Erosion Control Plan
for
PacifiCorp's Bigfork Hydroelectric Project
FERC Project No. 2652

January 20, 2004

PacifiCorp's Response to MFWP Comments re: Erosion Control Plan

Figure 3. Erosion Control Site 1 Plan.

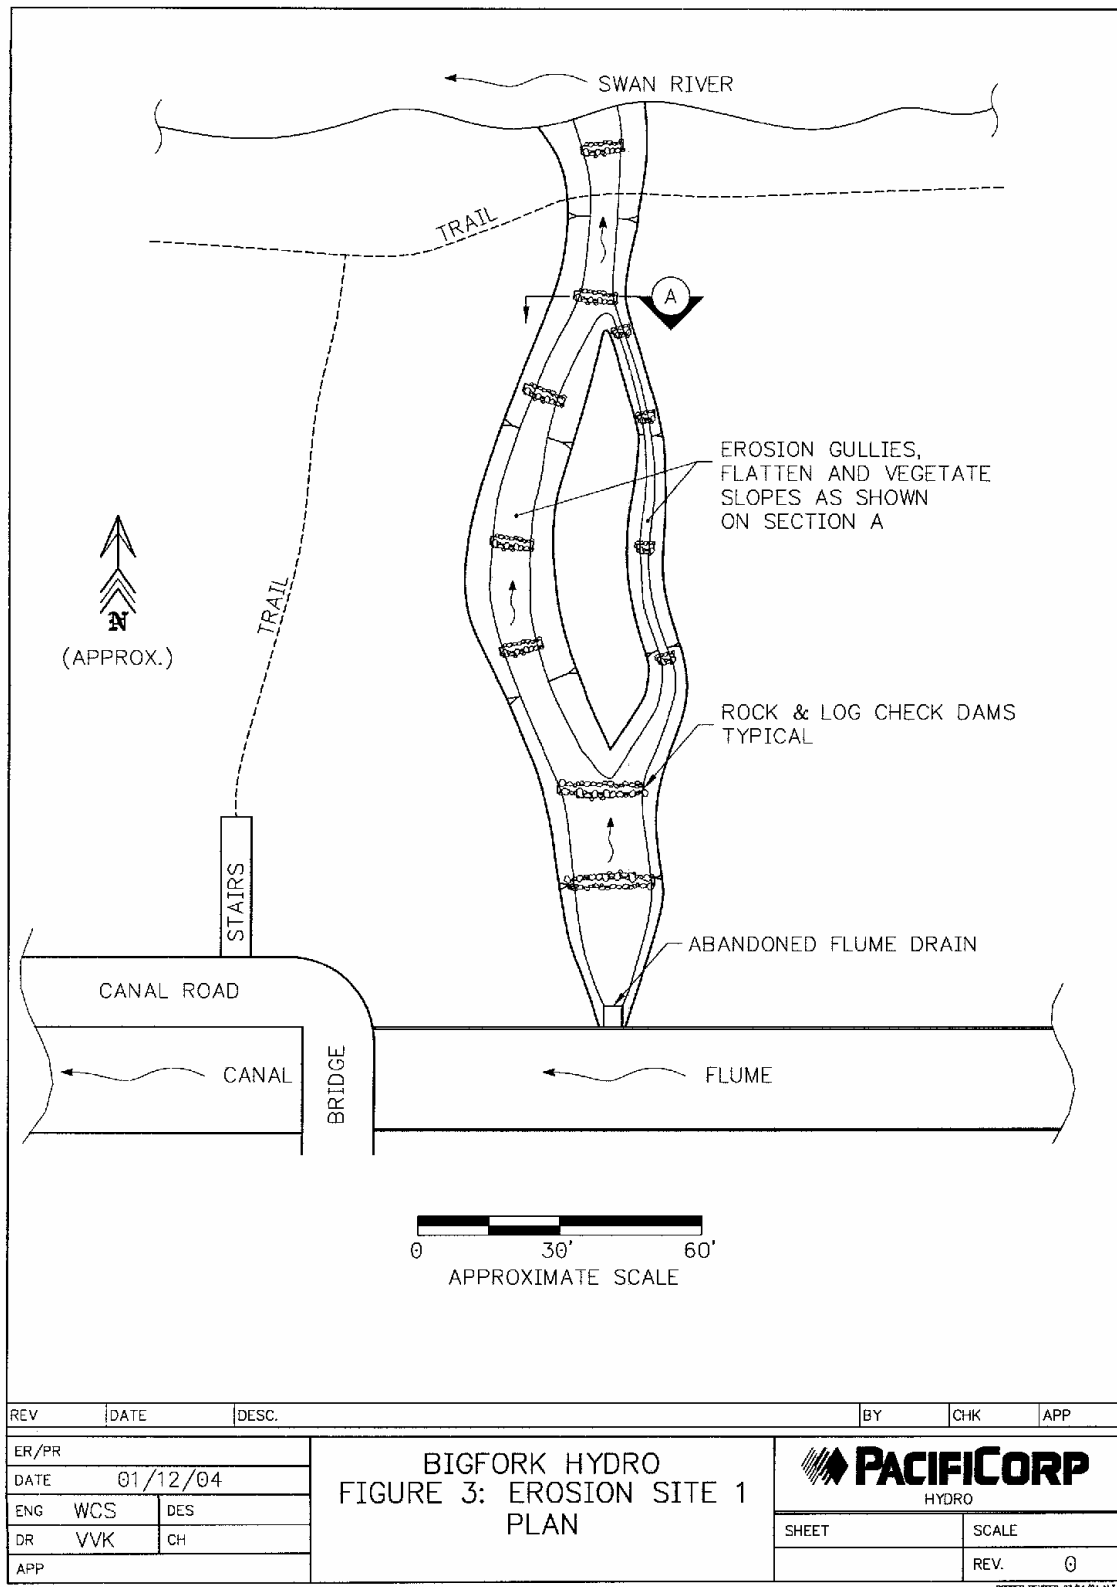
2. A more thorough plan should be developed to vertically and longitudinally stabilize the gullies surface with contouring and the installation of more suitable structures and extensive revegetation.

The erosion control plan for Site 1 proposes the installation of erosion control fiber-log check dams anchored with wood stakes on 25-foot intervals down the gulley.

The proposed structures do not appear durable enough for long-term stabilization and sediment control. Leaving the deeply eroded gullies in place will likely continue to concentrate future runoff and transport sediment.

A more thorough plan should be developed to vertically and longitudinally stabilize the gullies surface with contouring and the installation of more suitable structures and extensive revegetation. Check-dams should include

large rock and large woody debris for stability and longevity. Drainage features may need to be installed and fill material imported. A spider hoe would be very useful for this work and would minimize disturbance.

To stabilize the eroded drain channel, steep side banks will be flattened to approximately 1½ horizontal to 1 vertical (1½H:1V). Slopes may be locally steeper to avoid trees near the steep edge. The removed material will be placed in the channel to provide a fertile growing medium over the exposed gravels. Bare soil surfaces will be covered with native seed and a biodegradable erosion control mat. Native plantings will be placed through the coir mats to provide additional stabilization.

A series of check dams will be installed to trap sediment that may be dislodged during precipitation events. Each dam will be installed approximately every 25 feet apart as shown on Figure 4. Check dams will consist of rock and woody debris obtained from on-site materials as shown on Figure 4. The work will be performed with a small excavator or spider hoe to minimize impacts to the landscape.

PacifiCorp has revised the plan to include flatter slopes, rock & log check dams, and revegetation to stabilize the erosion sites (See Section 3.2 – Site Specific Erosion Control Measures).
